# Access Compliance Report

## Public Rights-of-Way

### (Curb Ramps)

Intersection ID: 18216	Main Street: FOREST_DR	Cross Street: S_WENDOVER_RD	Location: E
ADA ID: A43C596767A2	Ramp Type: PerpDiag	Initial Pass/Fail: Fail	Overall Compliance: No
			Severity Score: 13.75

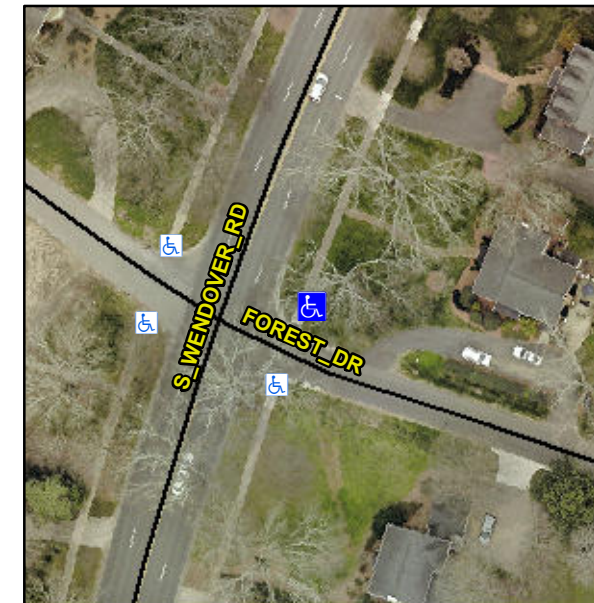
**Not Found, R304.2.2, R304.5.3**

Compliance	Description	Data	Compliance	Description	Data
N/A	Ramp Length (in)	63.0	No	Ramp Slope (%)	9.0
Yes	Ramp Width (in)	48.0	No	Ramp XSlope (%)	3.7
N/A	Flare Type LT	N/A	N/A	Flare Type RT	N/A
N/A	Flare Slope LT (%)	N/A	N/A	Flare Slope RT (%)	N/A
N/A	Flare Traversable LT?	N/A	N/A	Flare Traversable RT?	N/A
N/A	Landing Length (in)	N/A	N/A	DWS Provided?	N/A
N/A	Landing Width (in)	N/A	N/A	DWS Contrast?	N/A
N/A	Landing Slope (%)	N/A	N/A	DWS Length (in)	N/A
N/A	Landing X Slope (%)	N/A	N/A	DWS Full Width?	N/A
N/A	Landing Curb? (Y/N)	N/A	N/A	DWS Offset (in)	N/A
N/A	Shared Landing?	N/A			
N/A	Gutter Ponding?	N/A	N/A	Gutter Slope (%)	N/A
N/A	Gutter Lip Ht (in)	N/A	N/A	Gutter X Slope (%)	N/A
N/A	Painted X Walk1?	No	N/A	Painted X Walk2?	No
	X Walk 1 Direction	To NW		X Walk 2 Direction	To SW
N/A	X Walk 1 Width (in)	N/A	N/A	X Walk 2 Width (in)	N/A
	X Walk 1 Slope (%)	2.7		X Walk 2 Slope (%)	0.7
	X Walk 1 X Slope (%)	0.8		X Walk 2 X Slope (%)	3.7

**Remove & Replace Curb Ramp With Two New Directional Ramps or Equivalent.**
